# TE's SW Path lighting proposal: -violates WisDOT guidelines -would *reduce* safety of SW Path users

Perry Sandstrom BSEE

Daily (and often nightly) Southwest Path biker & runner  
11/25/12 - Southwest Path Alliance - Facebook/owlpath

# Figure 1. Current Overhead LED Proposal

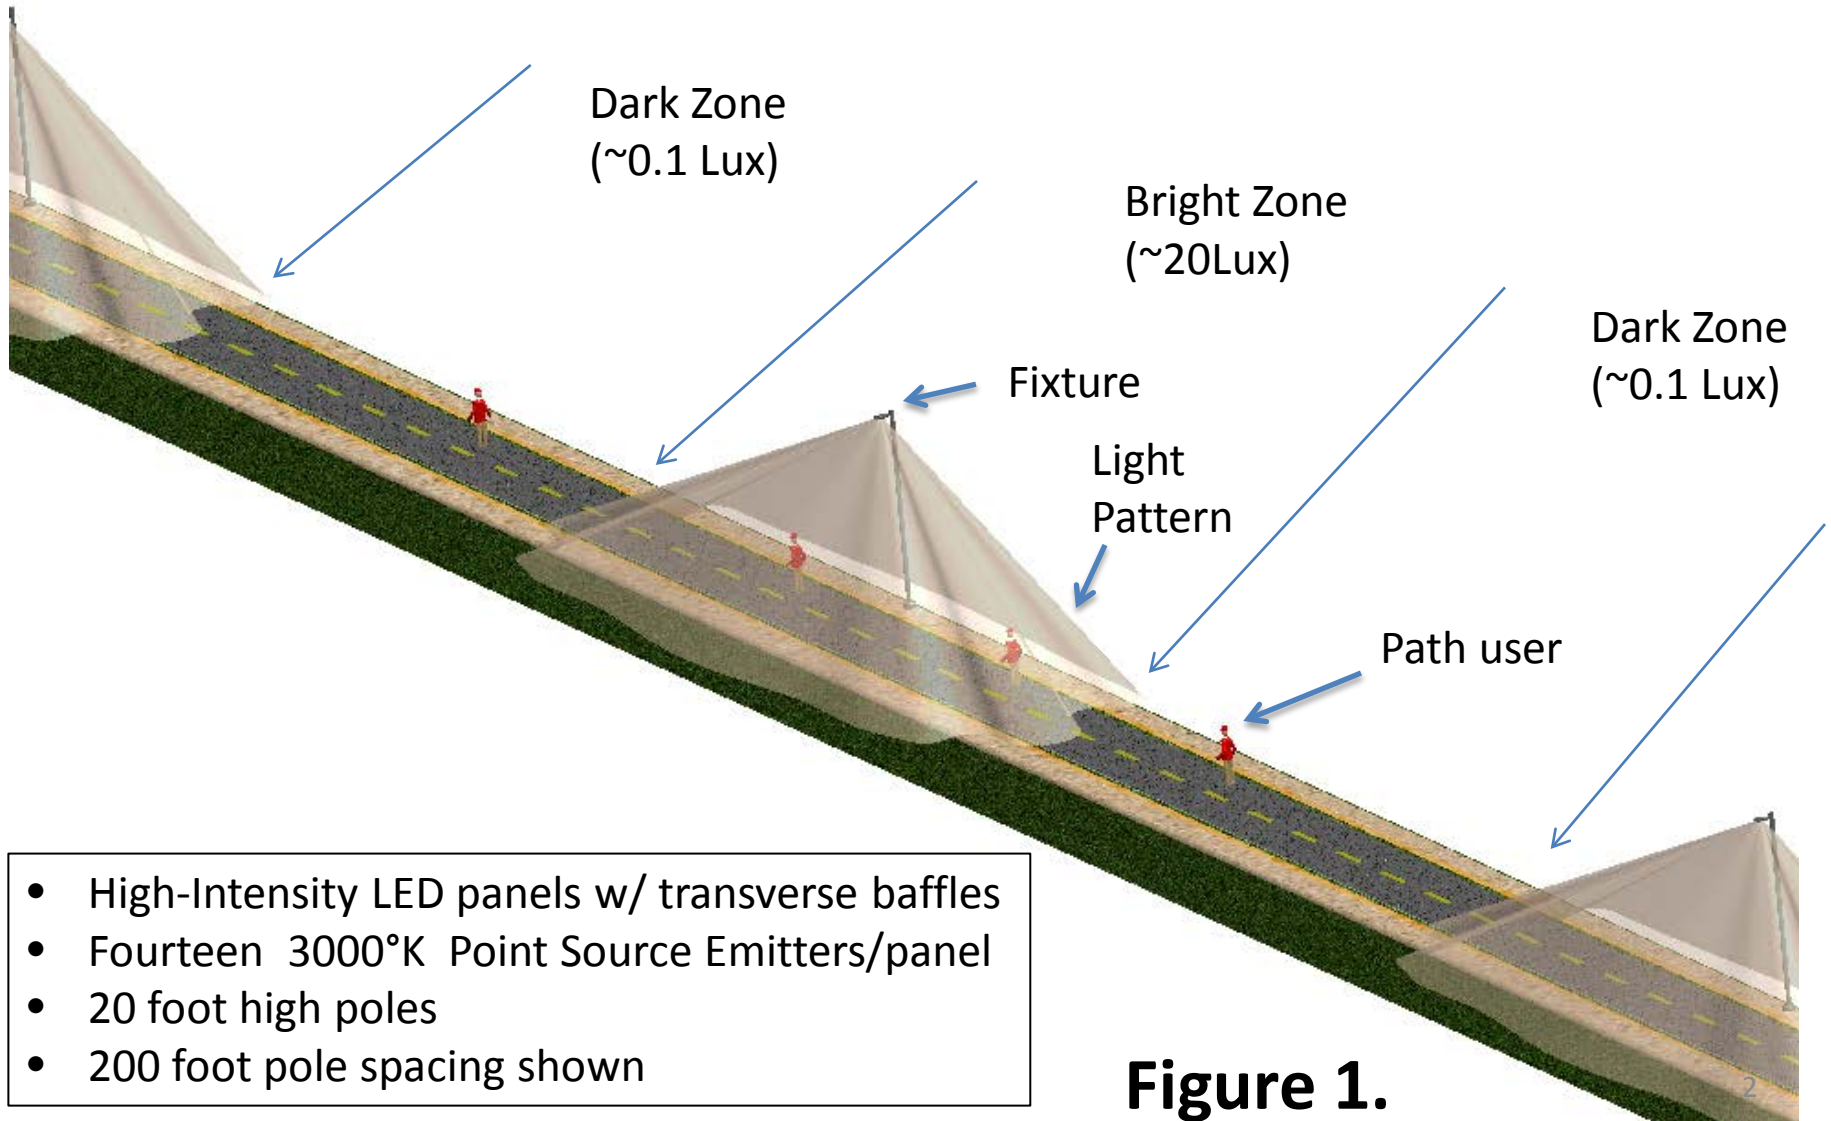
# Project does not meet WisDot Guidelines for uniformity

**Figure 2.**

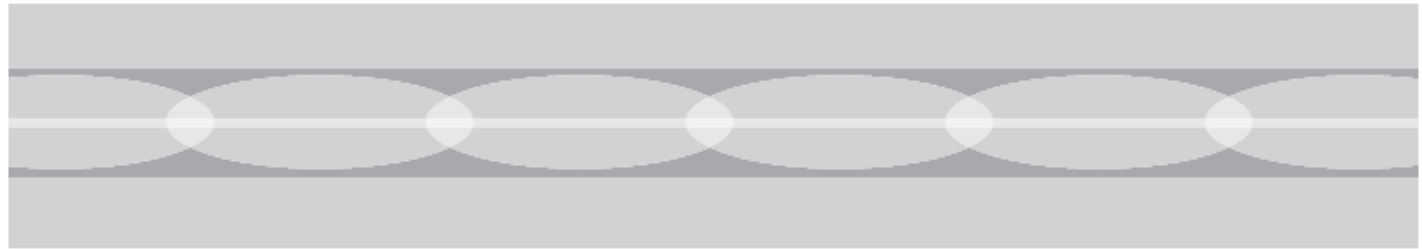
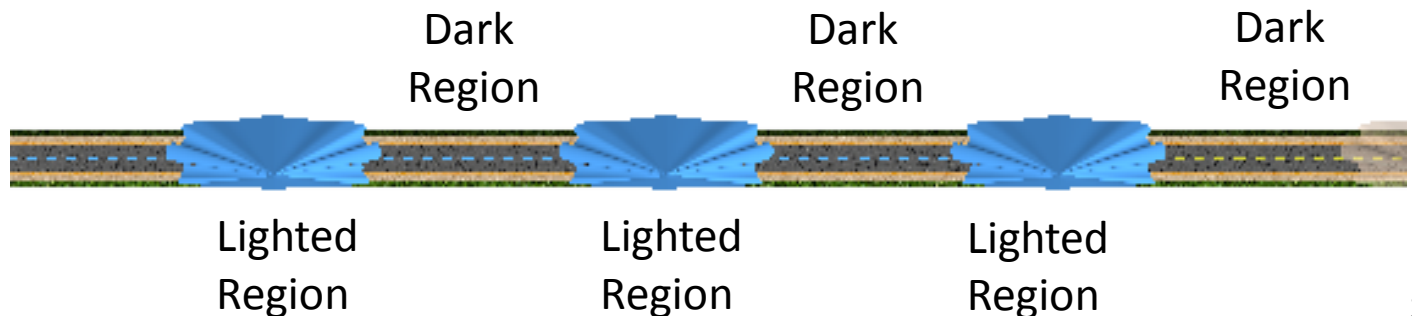
WisDot  
Handbook:  
(overlap)

Proposal:  
(no overlap)

**Figure 3.**

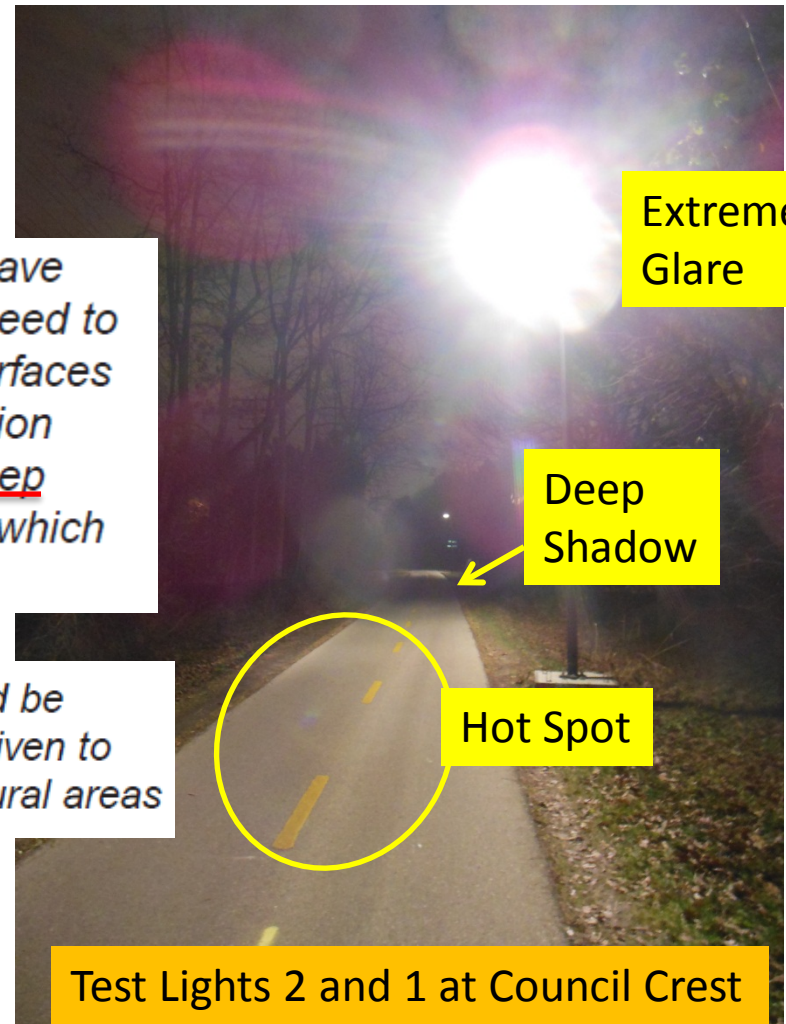
# Project Violates WisDOT Guidelines for path vision and glare

- **Night vision:** Both bicyclists and pedestrians have specific requirements for nighttime seeing. Both need to see small obstacles and changes in pavement surfaces to feel safe using paths at night. Uniform illumination should be provided that avoids “hot spots” and deep shadows, and care must be taken to avoid glare, which can compromise night vision.

- **Full cutoff:** Glare from cobra-style luminaires should be avoided in all cases. Particular attention should be given to pathways adjacent to residences, waterways, or natural areas

(these LED Fixtures are *higher* glare than cobras)

**Figure 4.**

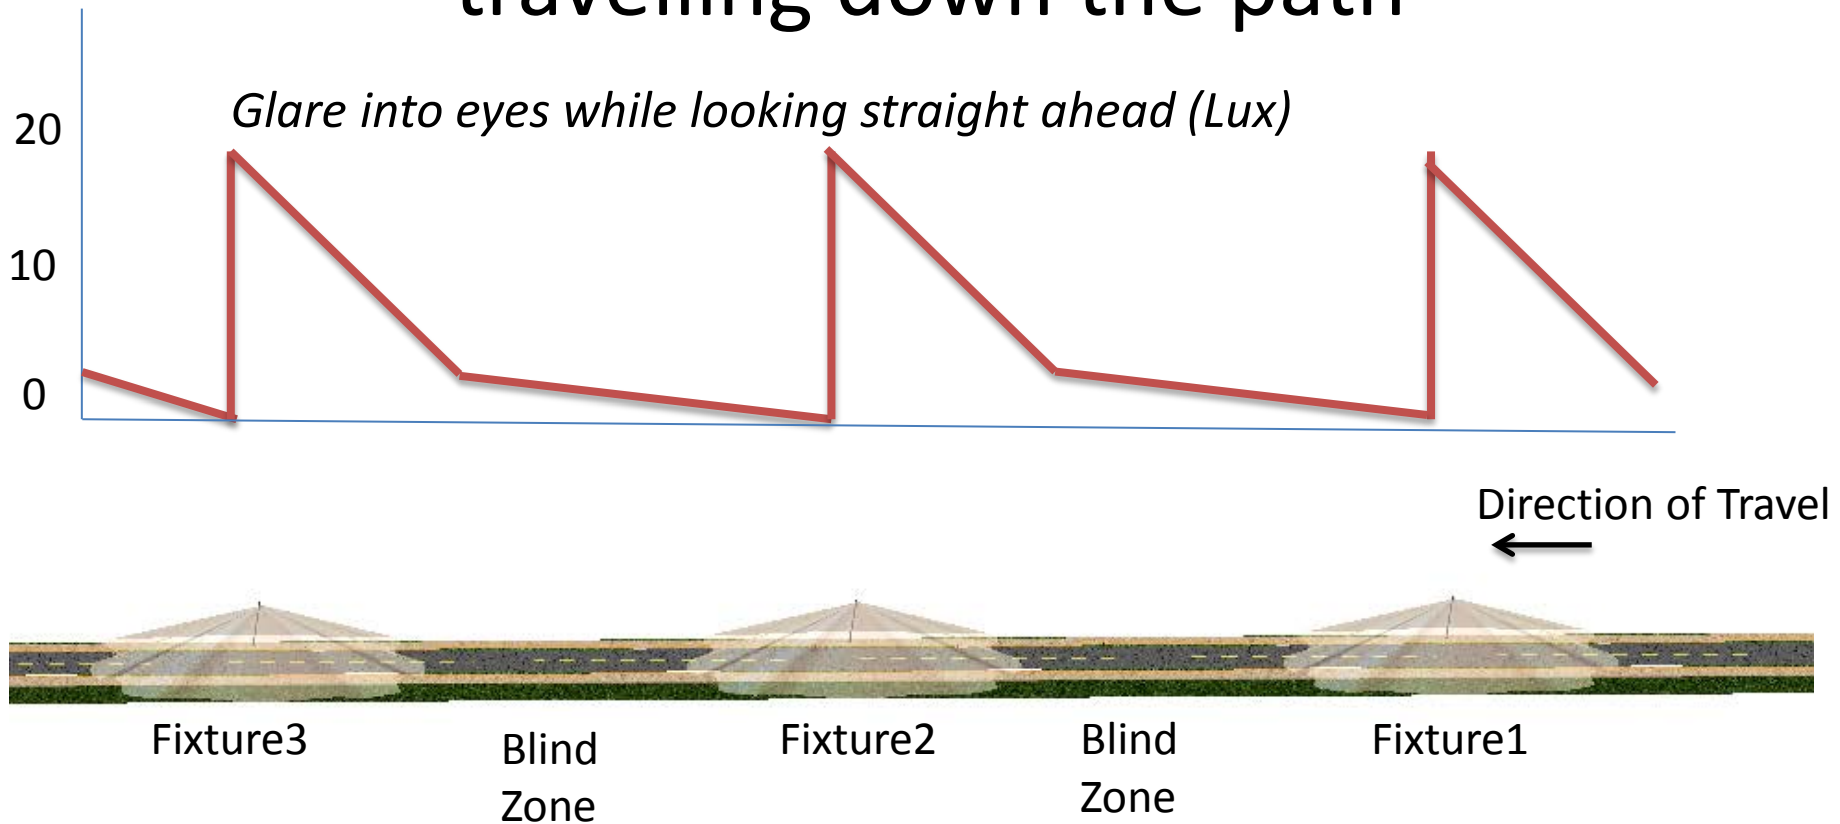
# Causes “Saw-tooth” Eye Adaptation while travelling down the path

Wide variation causes fatigue and overall reduction in visual acuity.  
Limited on streets by higher poles, closer spacing, type1 fixtures and car roofs.

**Figure 5.**

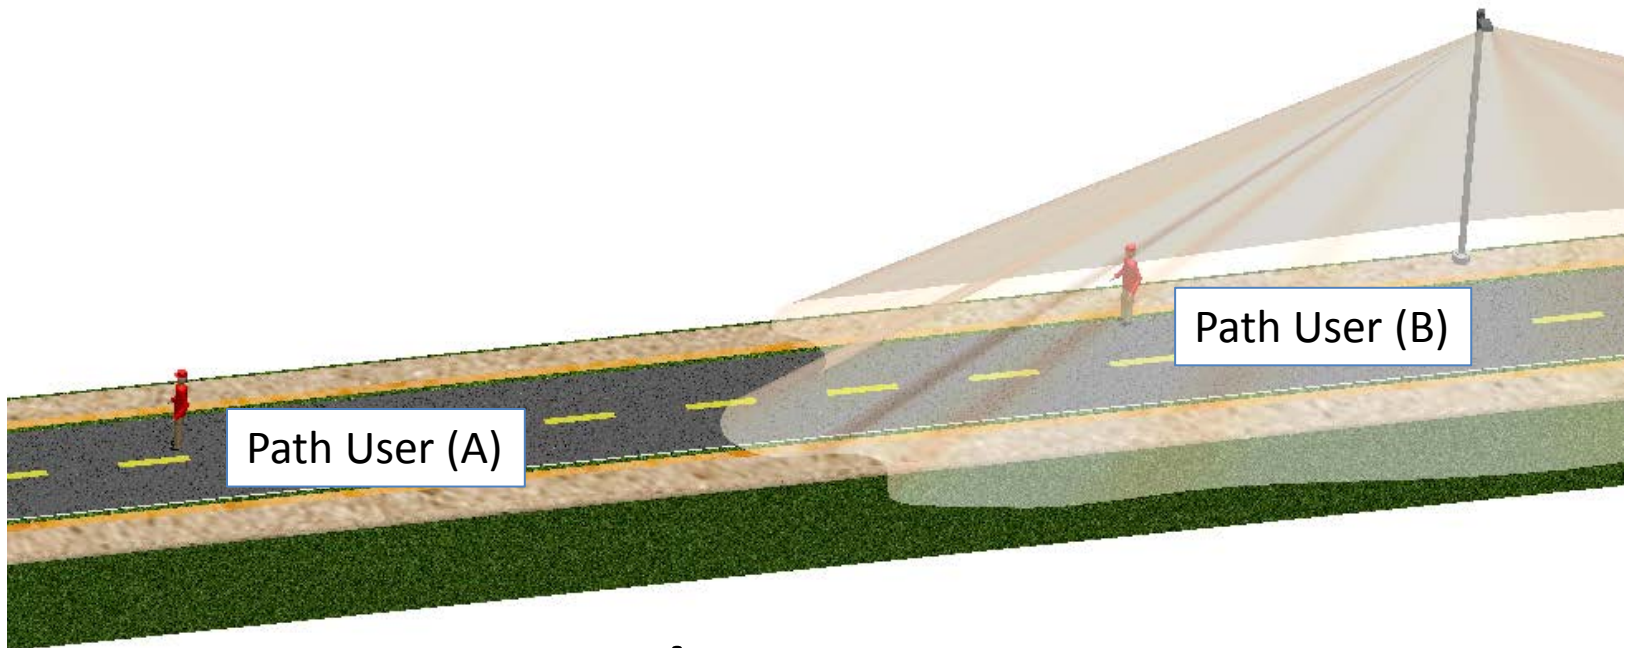
# Project will Introduce a Known Visibility Hazard

Path user (A) is difficult for Path User (B) to see because of Loss of B's dark-adaptation from glare and A's relative darkness

Figure 6.

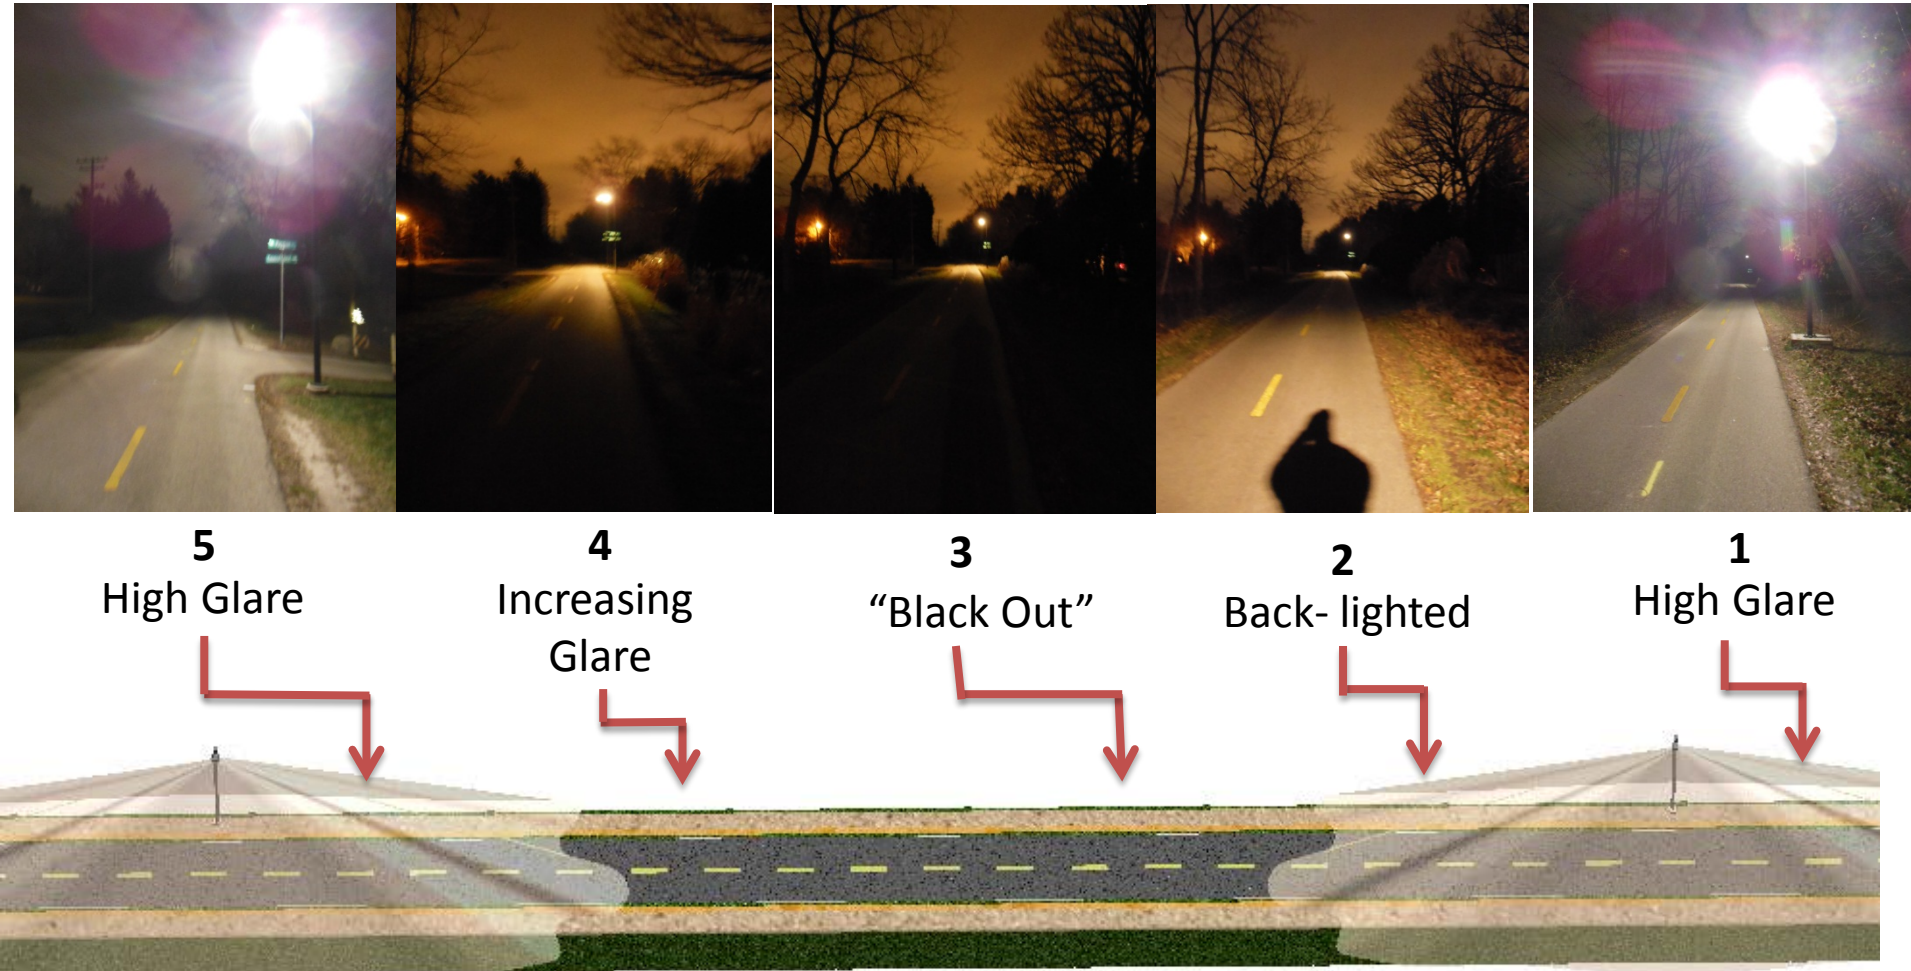
# Moving through transitions

Council Crest Test Light Pair; Walking NE

## Figure 7.

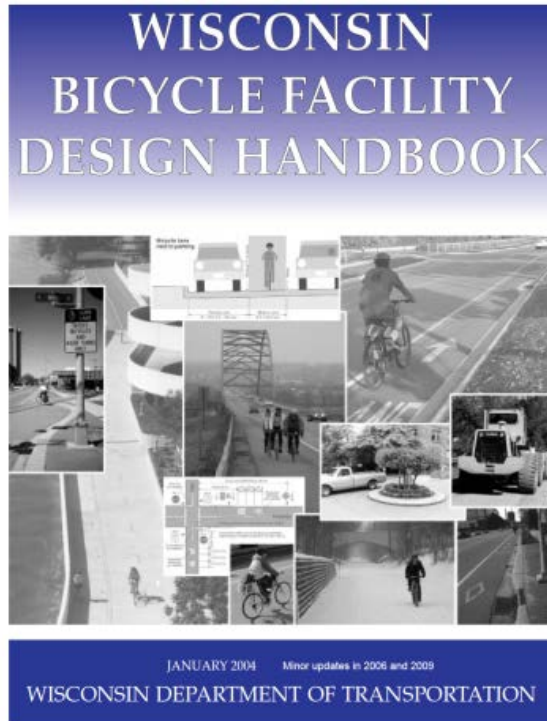
# Does project meet objectives anyway?

- Give greater “detection distance“ for “black-clad” pedestrians.
  - Sometimes, but not if they’re in the wrong place at the wrong time.
- Make path “more inviting” to new users.
  - Who knows?; Users would be “on stage” in isolated space w/ look and feel of a high crime area.
- Increase or at least not reduce current level of *actual* security.
  - Unlikely; Overhead lighting in isolated corridors can even facilitate victim selection
- Allow cyclists to see debris/ice on the path.
  - NO; Design actually obscures debris/ice in dark zones, even with bike light.
- Avoid discomfort glare and squinting.
  - NO;
- Retain visual cue for pedestrian of bike approaching from behind.
  - NO; Overhead lights wash out cues from ALL other lights and reflectors
- Make it so people won’t use high-powered front lights
  - Not likely, bikers would need more light than before for “fill in”
